SERVICE BULLETIN ASM-015

Product: Antenna System Monitor

Subject: Firmware 2.50e Release

Date: 25th February 2015

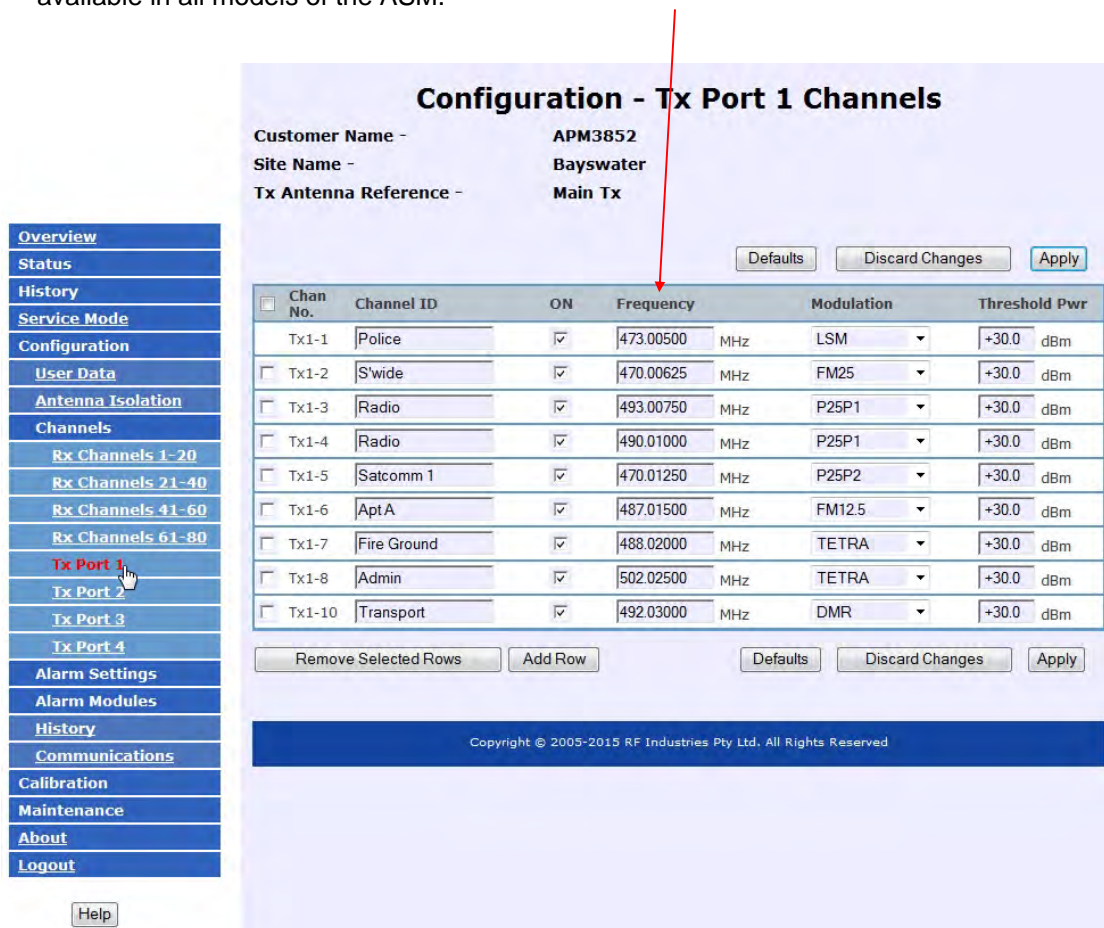
- i) If a SAM or CAM module is fitted to the ASM, and the PTT option is selected for a channel, no measurement will be made on that channel if the PTT line input is not active. In previous firmware versions the channel would be measured and then the measurement discarded if the PTT line was not active at the time.

This change allows the ASM to cycle through channels being measured more quickly.

If a PTT line is active when that channel is reached in the measurement cycle, a measurement of that channel is actioned, and if no valid output power above the configured threshold value is detected, then an alarm is raised to indicate a likely failed Base Station RF Power Amplifier output.
